| Intersection ID: 48135 | Main Street: HIGHLAND_CREEK_PY | Cross Street: SQUIRREL_TRAIL_LN | Location: | NW |
| ADA ID: CDA2E5B865C4 | Ramp Type: Perp | Initial Pass/Fail: Fail | Overall Compliance: No | Severity Score: 12.5 |

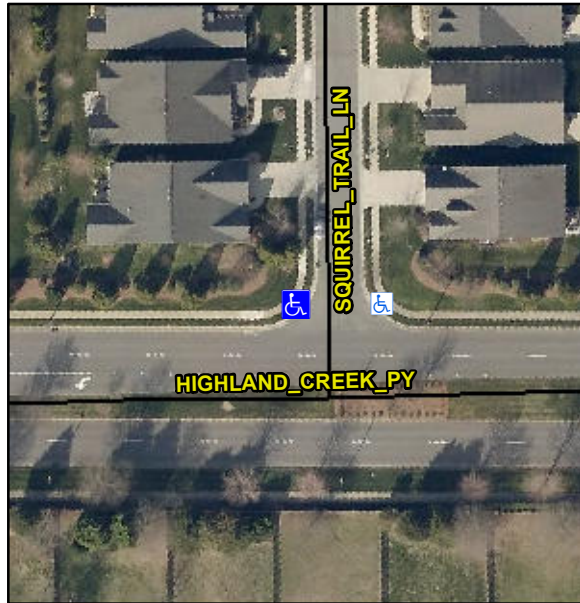
Not Found, R304.2.2

| Compliance | Description | Data | Compliance | Description | Data |
|------------|-----------------------|------|------------|-----------------------------|------|
| N/A | Ramp Length (in) | 49.0 | No | Ramp Slope (%) | 10.2 |

Remove & Replace Entire Ramp.
